KeContact P30

Software release notes Package 1.5

Version date: 13.10.2017

Date of release: 27.10.2017

2.2.9. New feature: WIFI

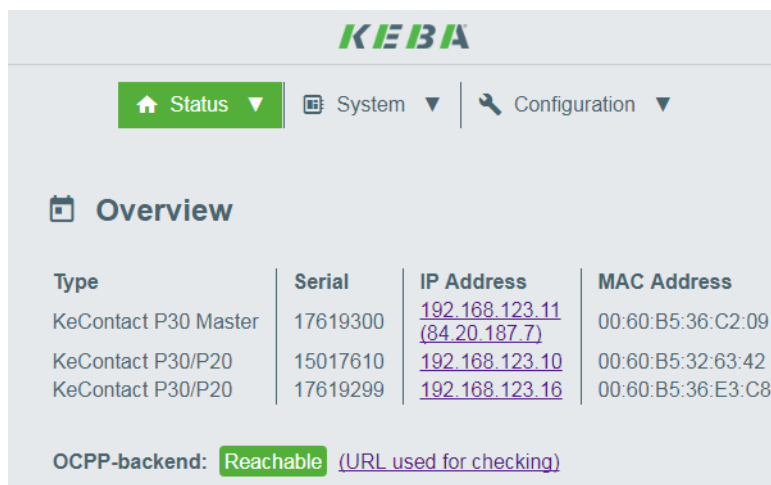
With this new feature it is now possible to activate the already built-in WI-FI module in the electronics of the KeContact P30 x-series.

You can configure your KeContact P30 x-series to connect to an existing WI-FI network or to be used as hotspot. For more details on how to configure and use the WI-FI function please read the configuration manual.

3.2.1. Unused logs have been removed

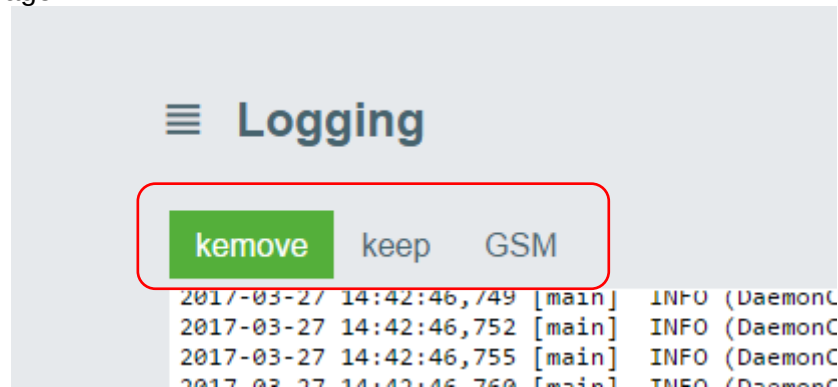
Unused tabs like "kremove-wrapper" and "keep-wrapper" have been removed from the logging web page.

Old web page

New web page

4.3.5. WebUI – Logging

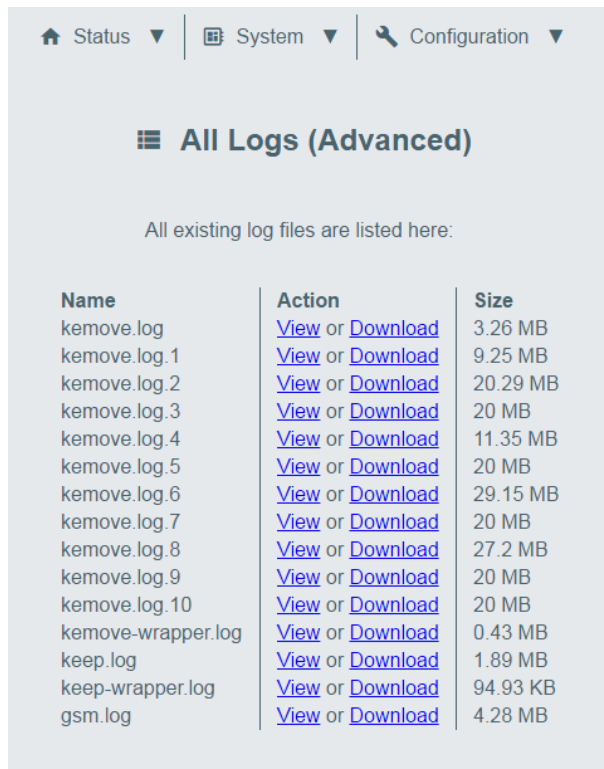
Added "All Logs" button to "Logging" tab, allows individually viewing and downloading every single log file.

Here is shown a screen shot of what the user can see if clicking on “ All Logs”.

4.3.7. WebUI – component version

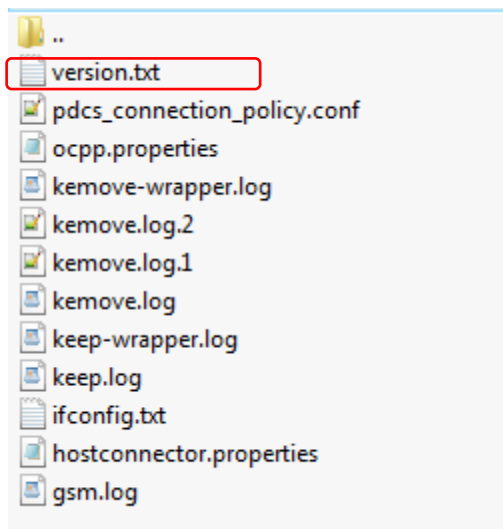
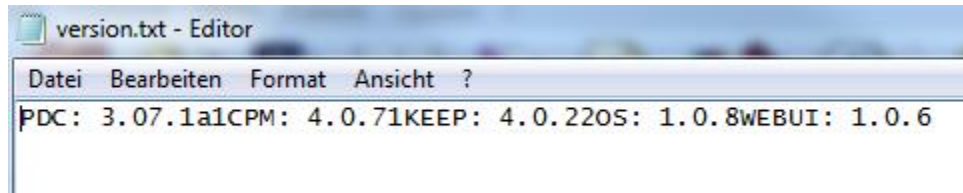
Added the text file “version.txt” in zip file accessible by clicking on "Download Latest".

In this file are enclosed the information related to the versions of the software component.
